PROJECT NAME: GREENWAY ESTATES

PROJECT NUMBER: 2023040043

APPLICATION: IMPROVEMENT PLAN #31022

Sheet No.
C001
of
C010

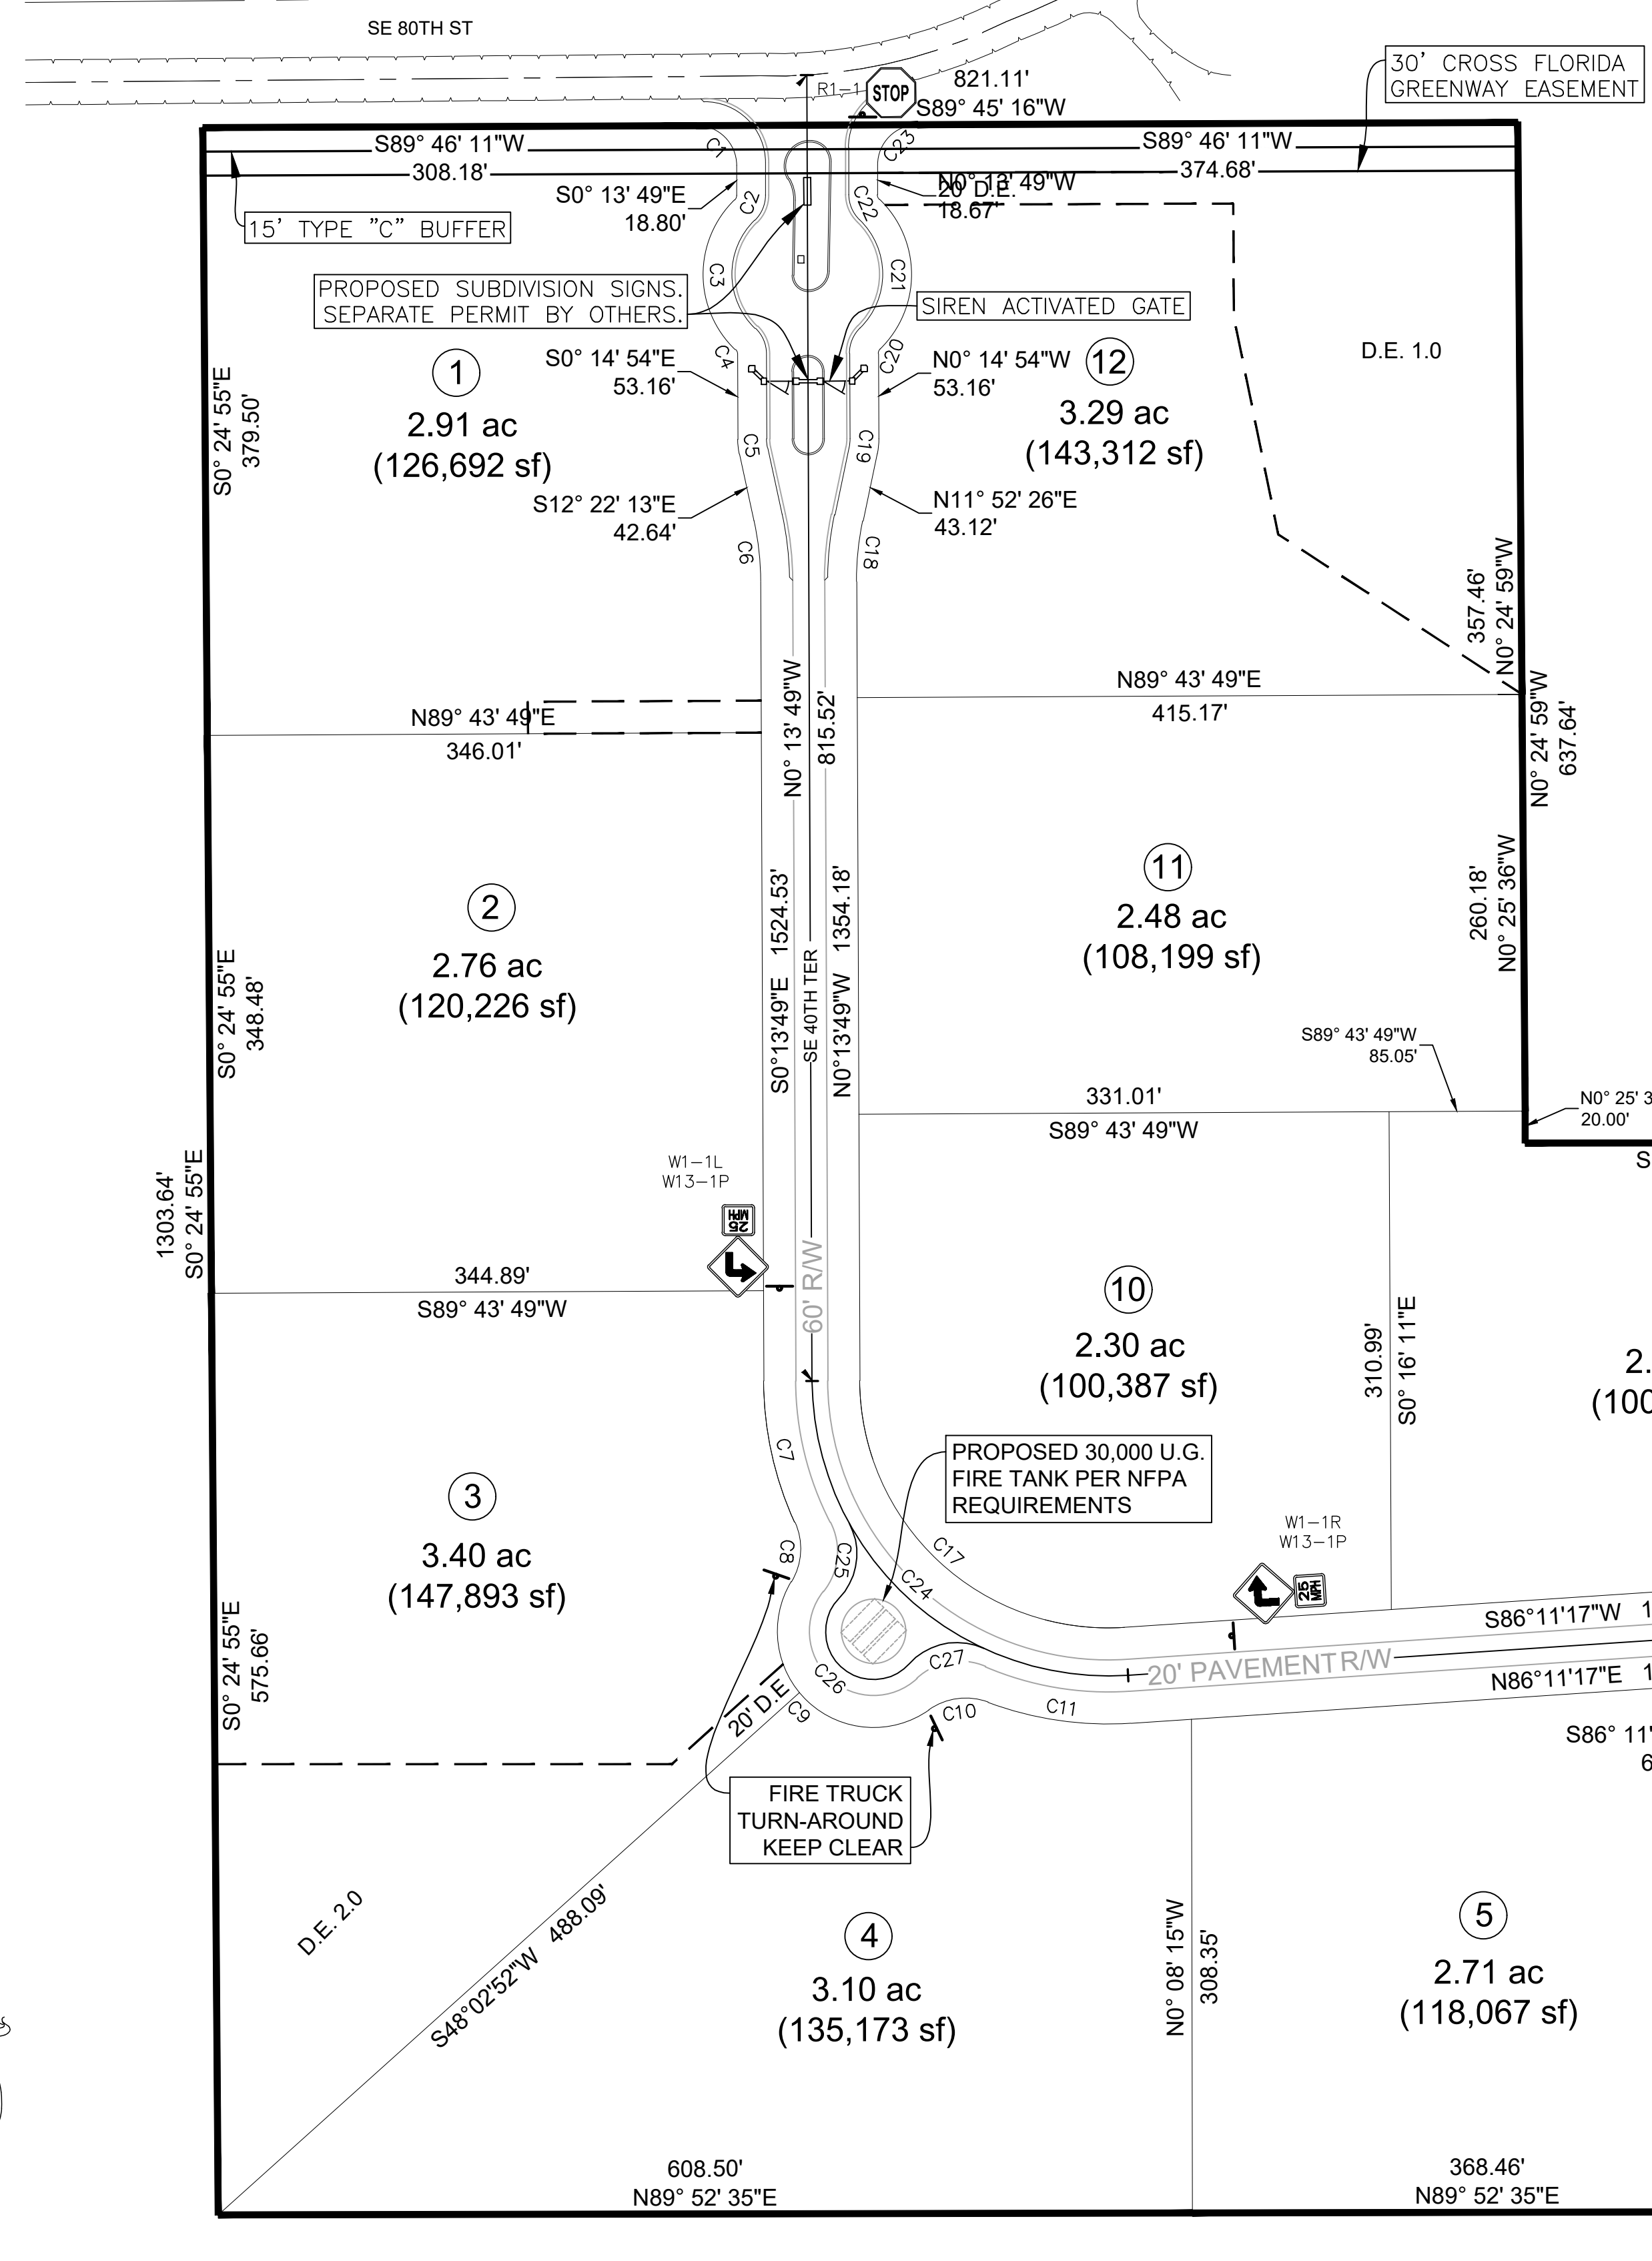
REMARKS: Please provide data block on the cover sheet detailing the existing and proposed impervious & pervious area in SF, ac, and %. Please include any offsite drainage to your site in the data block.

- 36 DEPARTMENT: ENGDRN - STORMWATER REVIEW
REVIEW ITEM: Additional Stormwater comments
STATUS OF REVIEW: NO
REMARKS: (1) General Note 6 on the cover sheet states there are no FEMA or Marion County 100 year flood Plains on this site. There is a County Flood Prone area on the eastern boundary of this site. Please clarify. (2) The Drainage Summary on the Cover sheet appears to state that the 100 yr./24 hour storm event is 11.0". Per the calculations, 11.5" was modeled. Please clarify. (3) The soil boring summary in the drainage report states that the borings were performed by Central Testing Laboratory, Inc. The geotechnical report submitted is from Florida Geotechnical Services, LLC. Please clarify. (4) If you have questions or would like to discuss the stormwater review comments, please contact Kevin Vickers, PE at 352-671-8695 or kevin.vickers@marionfl.org.

- 47 DEPARTMENT: UTIL - MARION COUNTY UTILITIES
REVIEW ITEM: Marion County Utilities Contact Information
STATUS OF REVIEW: NO
REMARKS: Cover sheet - change Marion County Utilities/Josh Kramer/352-438-2383 to the correct utility authority - City of Belleview Utilities and their required contact info.

TYPICAL LOT

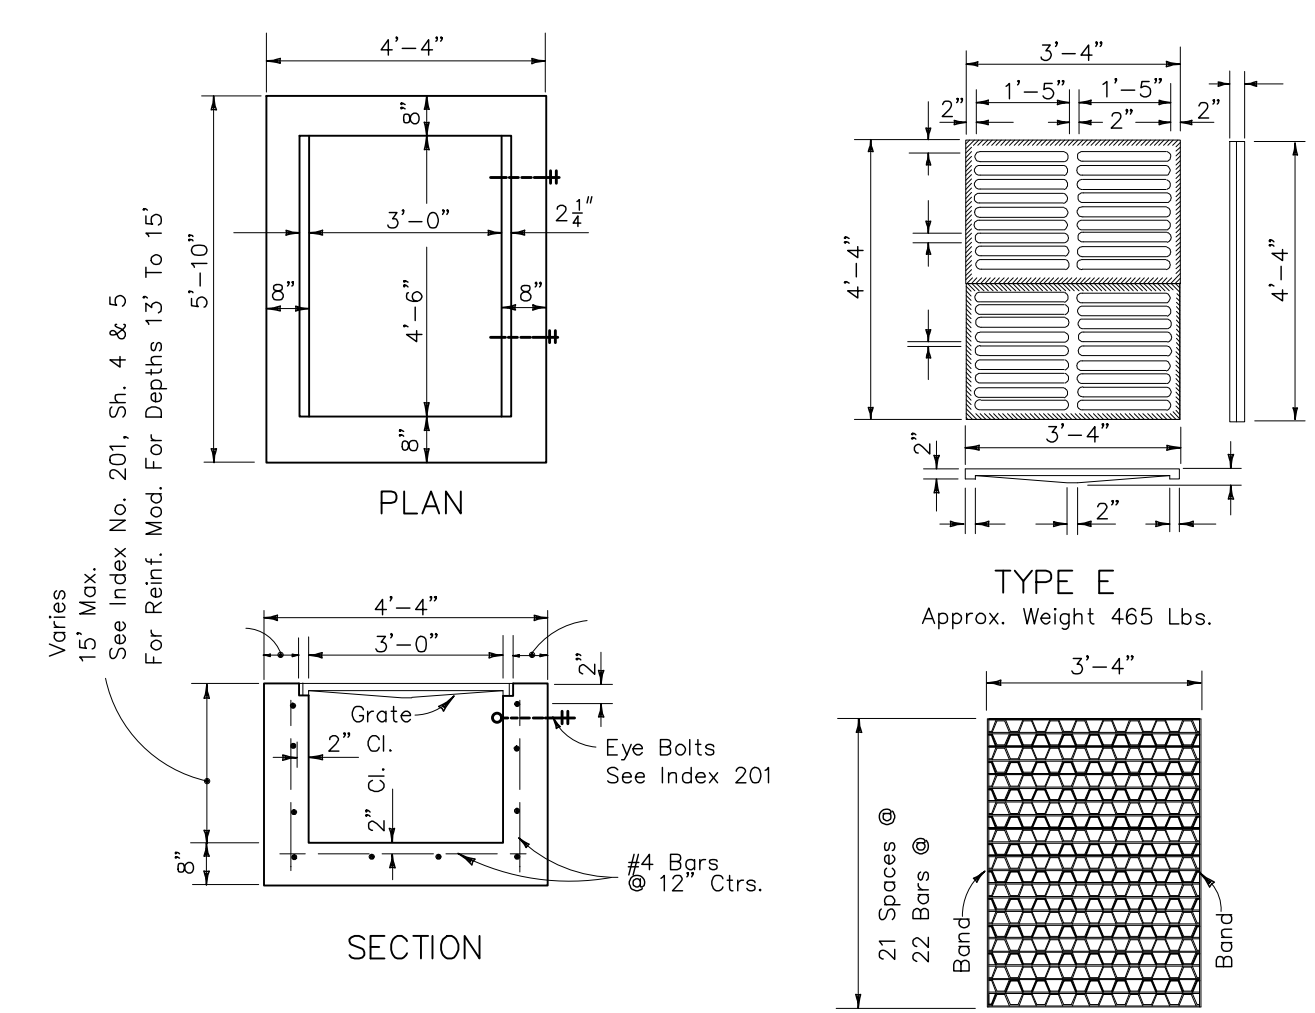
- 49 DEPARTMENT: ZONE - ZONING DEPARTMENT
REVIEW ITEM: 2.12.23 - Show typical setback layout for primary uses, as well as accessory uses, dimensions for all improvements
STATUS OF REVIEW: NO
REMARKS: Please provide a lot typical showing the "footprint" of a lot along with the setbacks.
